City of Sandy

Planning Commission Meeting

4.1. 19-023 SUB/VAR/TREE Bailey Meadows Subdivision Feb. 11

5.1. 20-002 UGB Expansion for Gunderson Road

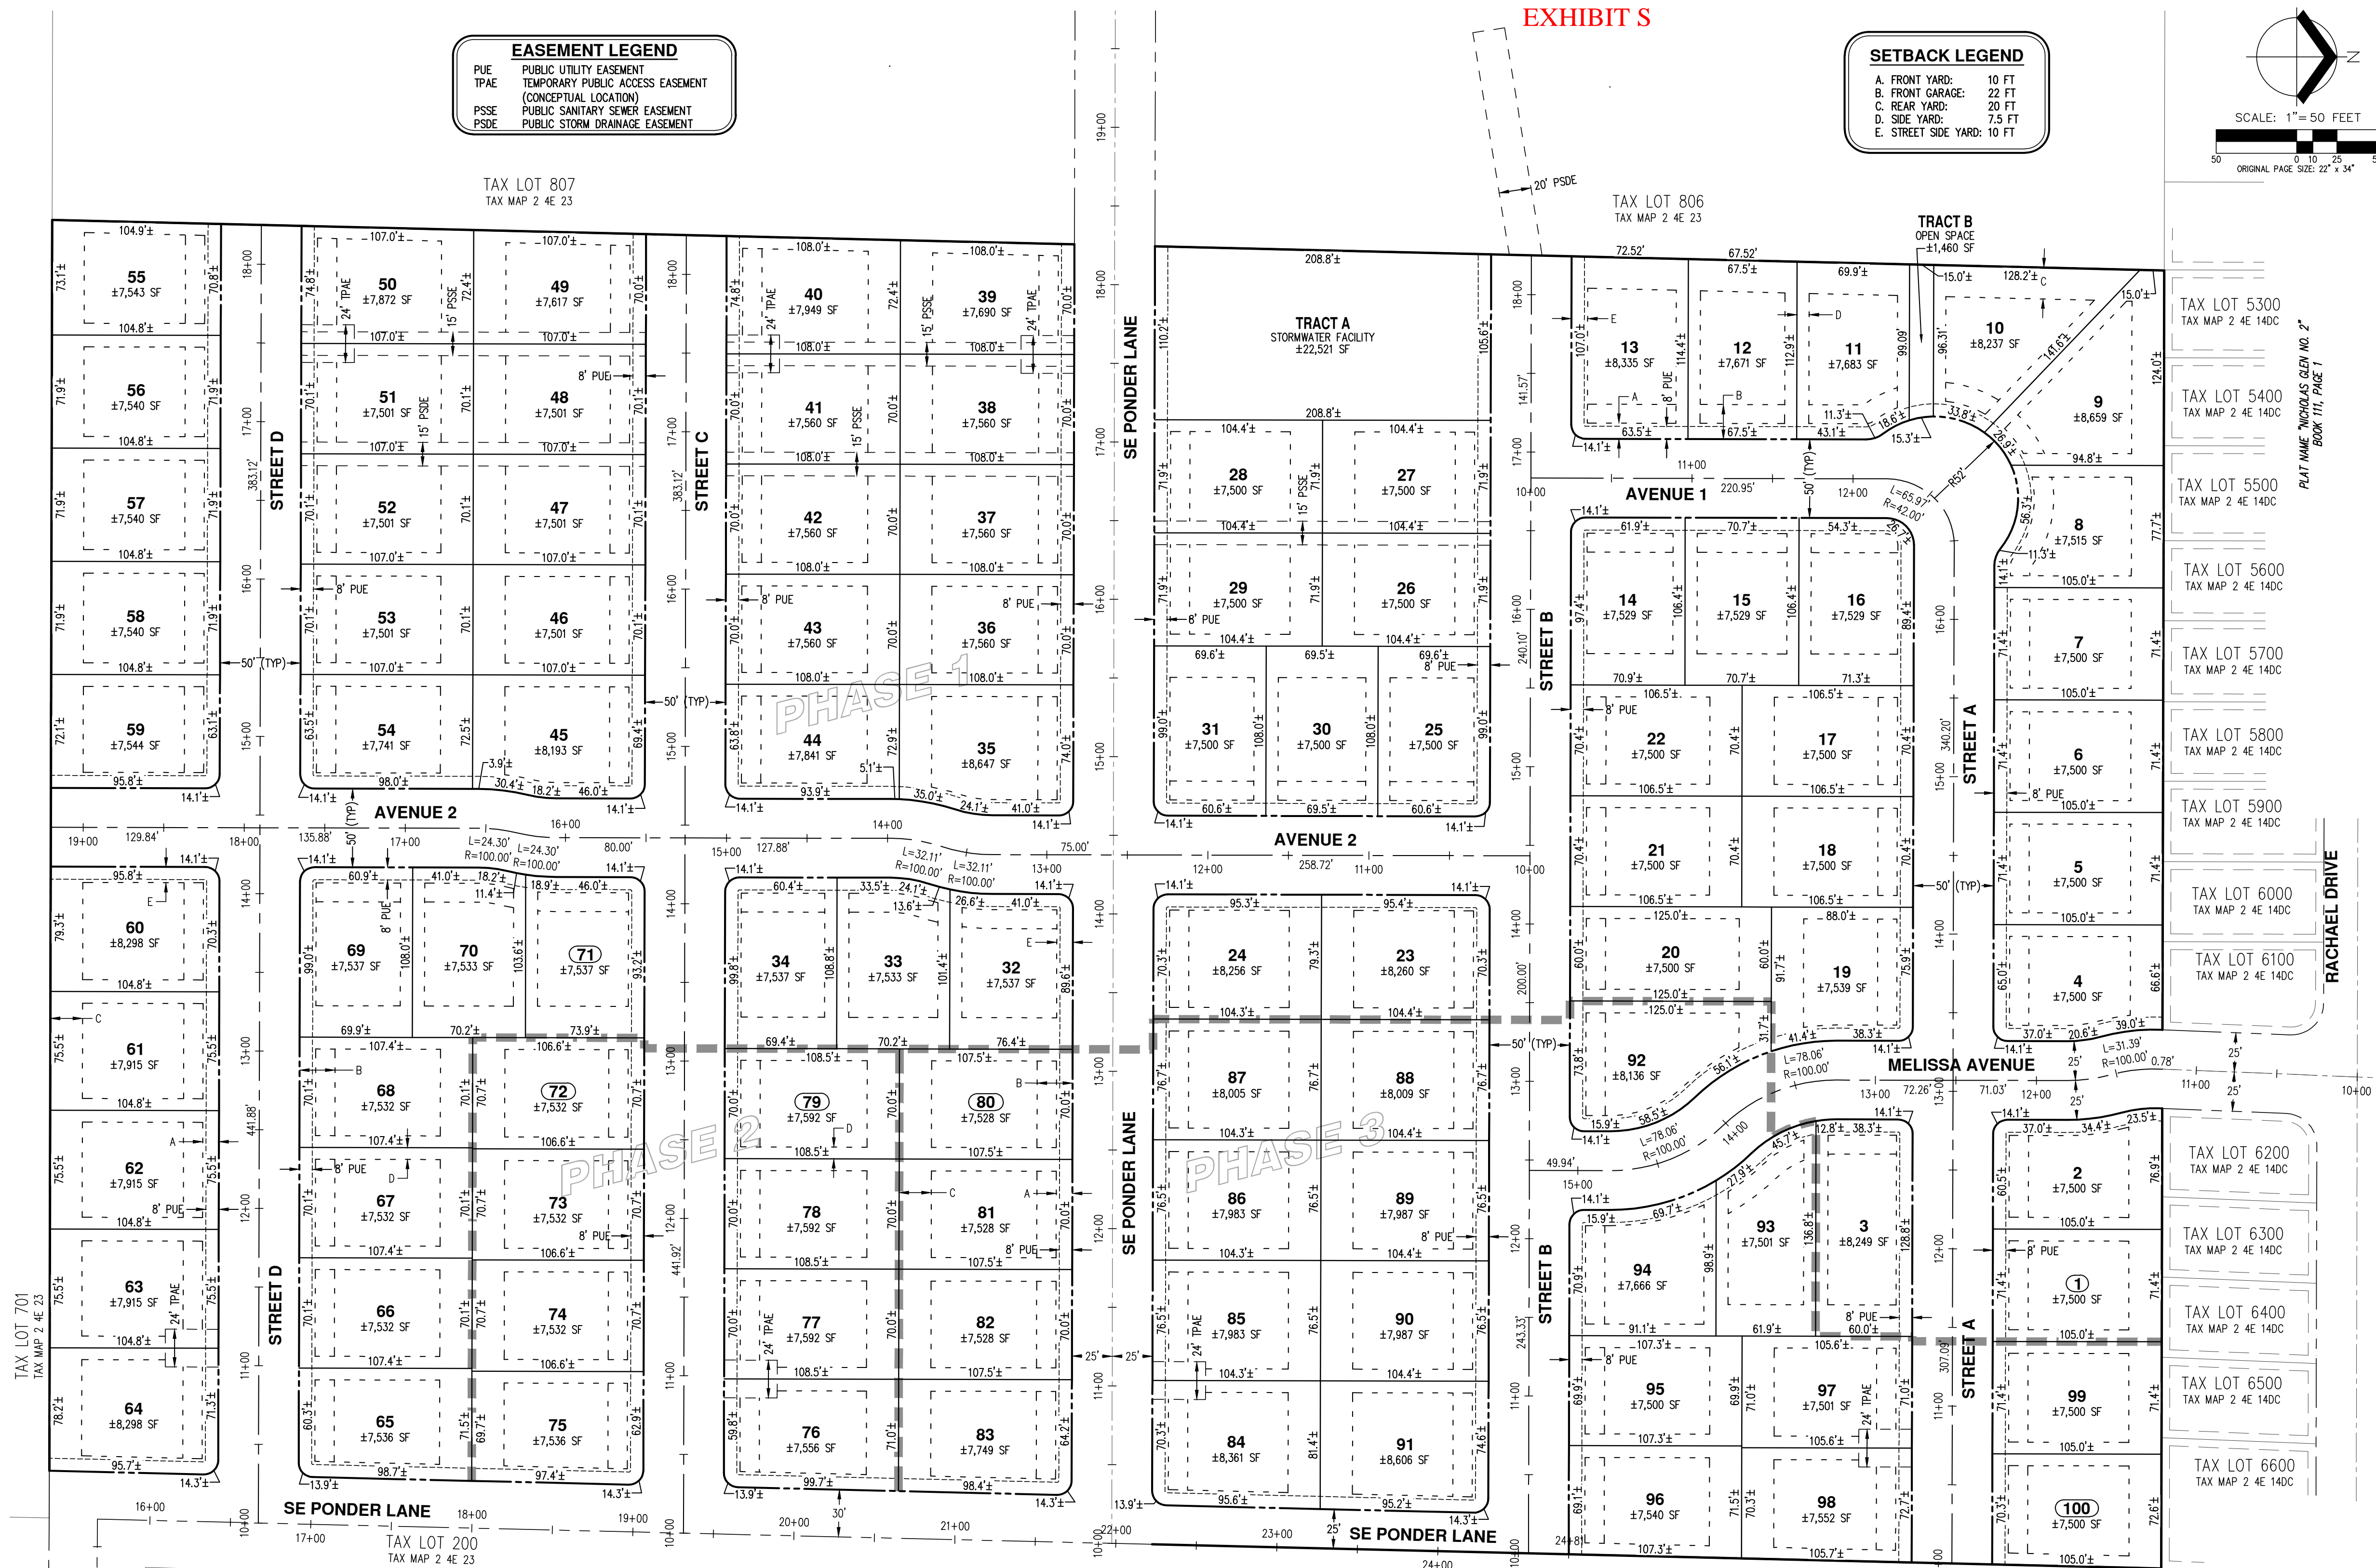
K. "Update the parking plan (sheet P-24) to detail which parking space is for which lot so we can confirm that there's parking spot within 200 feet of each lot."

RESPONSE: The updated Parking Detail Plan, **Exhibit 6**, is numbered to illustrate correspondence with each associated lot. Additionally, the furthest distances from associated on-street parking spaces are to Tax Lots 42, 47, 52, and 57 and are measured as shown to ensure the requirement is satisfied.
